Panguitch, Utah,

December 29, 1929.

Mr. Bert Peters,
Boulder, Utah.

In reference to the measurements made at the weirs on the Black, Ormond, Liston and Peters ditch:-

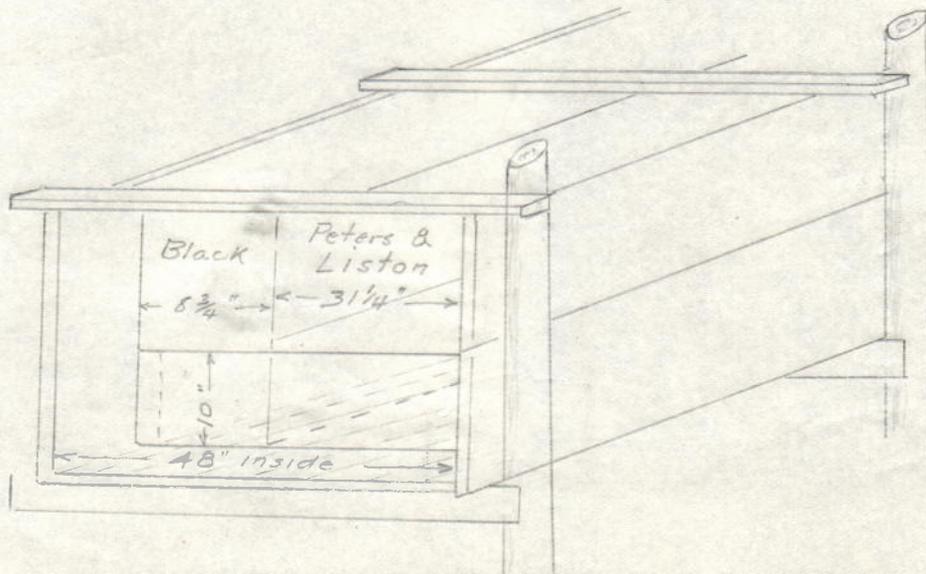
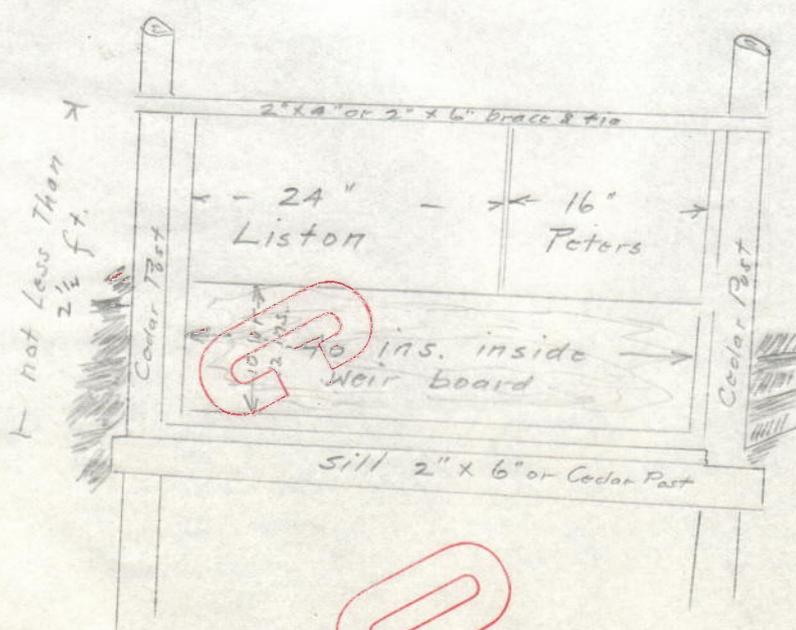
Weir No. 1 (otherwise the Ormond weir) takes $18/56$ of this stream permitting $38/56$ to go down to Weir No. 2 or the Black weir. As I have no data on the amount of water which Mr. Black takes through No. 1 I have not made any reductions.

The Weir No. 1 takes 0.3214 of the water to Messrs. Black and Ormond. Weir No. 2 takes $13/49$ of $38/56$ of the whole stream or 0.18 and both weirs together turn to Messrs. Black and Ormond 0.5015 of the stream belonging to all four parties. The water owned by Messrs. Black and Ormond amounts to $8/36$ of the stream and the two weirs give them $9.03/36$ which is an excess of $1.03/36$ or in normal water as decreed 0.25 cubic ft. per sec.

Amount decreed and established to above parties all together is 18/36 as shown above. Black and Ormond have 8/36 or 8 shares. The dividers placed by them allow 9.03 shares to go to them (Black and Ormond).

- 1:- Reduce the total width of the weir from 49 ins. to 48 ins. (Weir No. 2)
- 2:- Reduce the opening which diverts to Black to $8\frac{1}{2}$ ins. instead of the present size of 13 ins.

Divider No. 2 should be made 48" clear inside and the division diverting water to Mr. Black must be made $8\frac{1}{4}$ ins. wide in order to adjust the present error.
